## **Response to Reviewer 2**

The authors made a remarkable work to update the current state-of-the-art Antarctic SMB observational dataset, including SMB observations at different temporal resolution and covering different time period, with quality control. This dataset is unique and crucial for evaluating atmospheric models, in the absence of reliable precipitation observations in Antarctica. It is all the more important than SMB is driving the interannual variability of Antarctic ice sheet mass change and that its evolution under climate change is still highly uncertain, with potential significant contribution to sea level change during the 21st century. In this context, observational reference needed to improve the representation of SMB in atmospheric models is of much value for the whole earth system community.

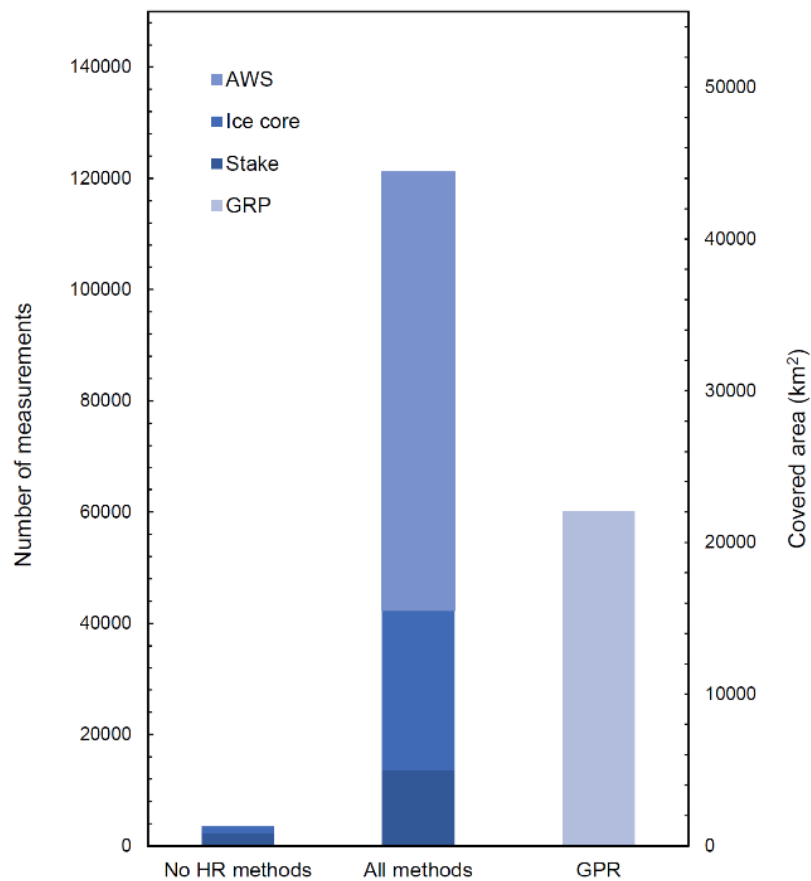
My main concern is about the number of observations given throughout the text. I think GPR numbers are not meaningful because GPR is continuous and the number of points is arbitrary. However it covers large areas. Can you give more meaningful numbers, such as the length or area covered? A solution would be to bin the GPR data points on a 1 km x 1 km grid and count the number of km<sup>2</sup> covered by the data.

I think you should revise the numbers for the following lines:

- p1 L14: "268913 individual multi-year averaged observations"
- p3 L76-78: "175373 individual GPR measurements"
- p7 L193-194: "including 265334 unique measurements by radar isochrones,"
- p11 L318-319 "Finally, 191816 multi-year averaged observations are left for model-observation comparison."
- p7 L194-198: "The majority of these observations (~ 69%) are derived from

airborne snow radar measurements in the coastal zone of West Antarctica and Antarctic Peninsula, Ronne Ice Shelf, South Pole, Pine Island and Thwaites glaciers (Medley et al., 2013; Medley et al., 2014; Dattler et al., 2019). GPR data from two transects in East Antarctica account for 30% of all measurements in this subdataset." + Figure 2

I think it's not fair to compare stakes numbers with GPR numbers. It makes more sense to compare the areas covered, e.g. using a 1km x 1km grid or a 10km x 10 km grid (number of pixels covered)

According to the above calculation, changes have been made accordingly for the number occurring in these lines. Also, we have re-drawn Figure 2. Following is the current Figure 2.

**We agree with you, and in the revised version, the GPR covered areas are calculated using 1km×1km grid. Changes have been made accordingly in the text.**

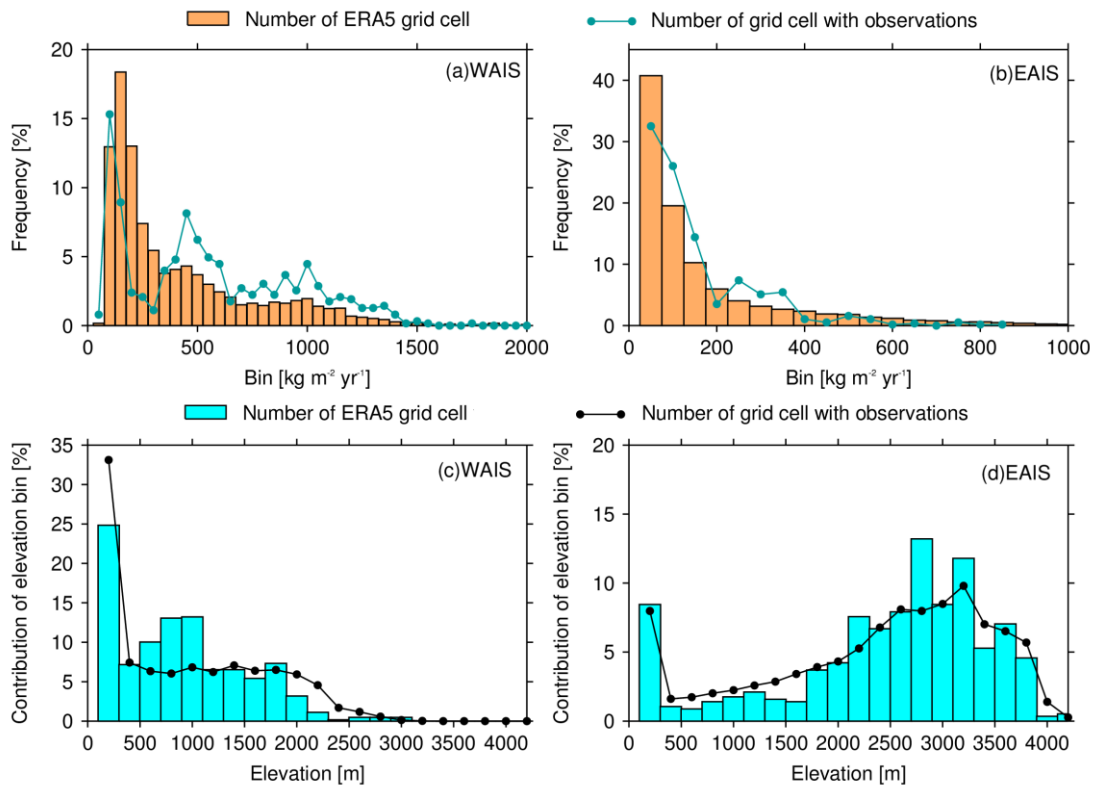
- p11 L342-344 "A comparison of the density distribution of ERA5 precipitation minus evaporation (P-E) with the filtered multi-year averaged SMB observations reveals that the multi-year averaged dataset is representative of the entire P-E spectrum of the model at the continental scale (Fig.6a)."

Are the histograms for observed multi-year SMB including individual GPR points and other kind of data? As stated above, I think it's not fair to compare the number of GPR points with other kind of data, so the histogram might be biased with GPR datapoint numbers.

I suggest to (1) bin GPR data (2) differentiate GPR data from other data in the histograms.

Looking at Fig.1c), one can also see that low-elevation datapoints are from GPR and are concentrated on WAIS. I suggest you separate Fig 6 into WAIS and EAIS to discuss the difference of coverage between the 2 basins, and change the conclusion accordingly.

**In the histograms, all the multi-year averaged SMB observations during the 20<sup>th</sup> century are used. We firstly calculate the averaged SMB for each 30×30 km grid cell (values from points located in the same grid cell are averaged). ERA5 fields are also bilinearly interpolated over a 30 km Cartesian grid. The 30 km grid is chosen due to the spatial resolution of ERA5 (~31km). Then we compare the contribution (relative frequency) of each bin (50 kgm<sup>-2</sup> yr<sup>-1</sup> wide) to total SMB. Lastly, we estimate the representativeness of elevation area distribution of SMB observations by the comparison between the contribution of areas with measurements in each 200 elevation bin, and those from ERA5 SMB field. In a word, here we bin all multi-year SMB observations using a 30×30 km grid, and thus, we do not compare the GPR number with the other kind of data.**

**Thanks for your good advice. Following your advice, we discuss if the AntSMB dataset is representative of P-E spectrum of the model over the WAIS and EAIS, respectively. Following is the re-drawn Fig. 6. Corresponding changes have been made in the text.**

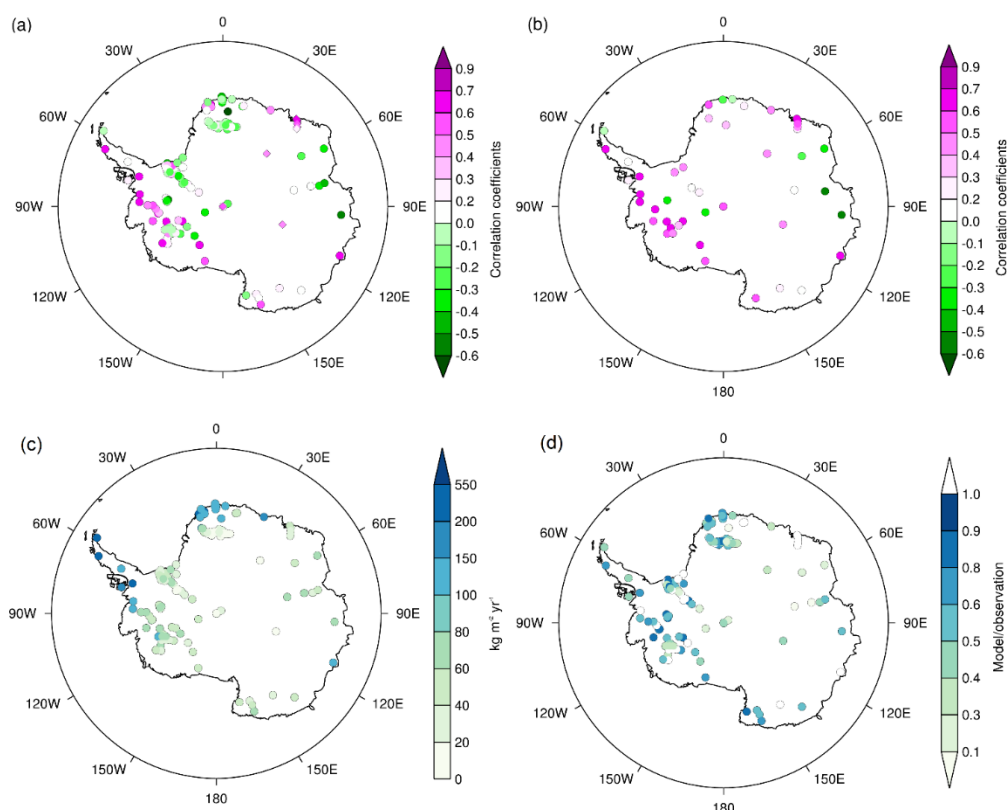
→ Can you separate ice cores and other data to assess if there is a real problem specifically with SMB interannual variability in ice cores? It is of importance as annual SMB observation from ice cores have been used to create the widely-used SMB reconstruction from Medley and Thomas (2019).

→ Can you also check for interannual variability (std of annual values) : ice cores vs. other observations vs. ERA5?

As shown in the following Figure 5 of the current version, we separate ice cores from other types of measurements. The corresponding changes have been made in the text.

**In current version, the comparison of interannual variability in SMB between ice core/other observations with ERA5 for their overlapping period have been added.**

**Figure 8: Cumulative daily snow accumulation and snowfall over time for each**

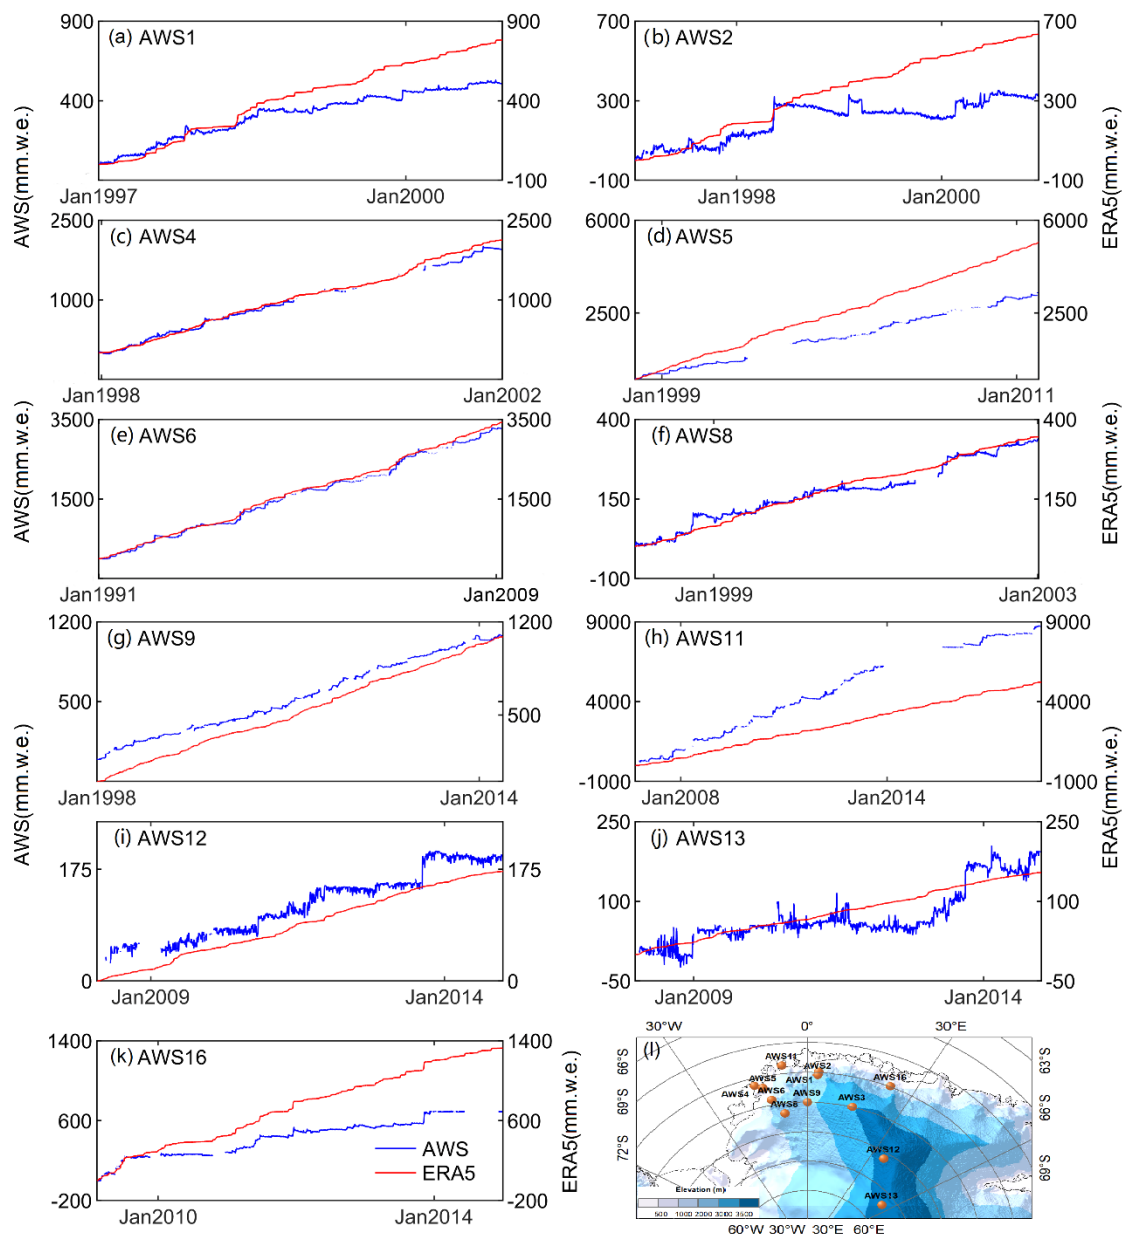
→ You should add a comparison with AWS, at least at some key sites, to assess the usefulness of this dataset.

**Liu et al. (2019) used AWS snow accumulation observations included in our AntSMB dataset over the Ross Ice Shelf, and inland East Antarctic Plateau to estimate the performance of ERA5 on the synoptic scale. To avoid repetition, we have added a comparison between ERA5 outputs and AWS observations over the Dronning Maud Land. They are as follows.**

*“A recent study showed that ERA5 present relatively good skills for representing snow accumulation changes on the synoptic timescale, observed at the AWSs over the Ross Ice Shelf and along the traverse route from Zhongshan Station to Dome A, with 56%~88% of extreme snowfall events captured (Liu et al., 2019). Given that these AWS observations are included in our AntSMB dataset, to avoid repetition, here we make a comparison between cumulative daily snowfall from ERA5 and the corresponding accumulation records from 11 AWS observations over the DML (Fig. 8). Obviously, gaps in the AWS records occur in most stations because of the problems of sensors or data transmission. Snow accumulation decreases in the daily cumulative AWS records, and reflects the important role of drifting snow,*

*compaction, sublimation or even ablation in the accumulation changes. Despite the noises of these post-deposition processes, stepped increase are observed for both ERA5 snowfall and AWS snow accumulation at each station in Fig. 8. Furthermore, the occurrence of large snowfall events are in broad agreement with the corresponding large accumulation events at all stations. These suggest in spite of the limits of AWS measurements due to the complex impacts of post-deposition noises, they are an important source of ground-based measurements for evaluating synoptic changes in the precipitation from reanalysis products or climate models.”*
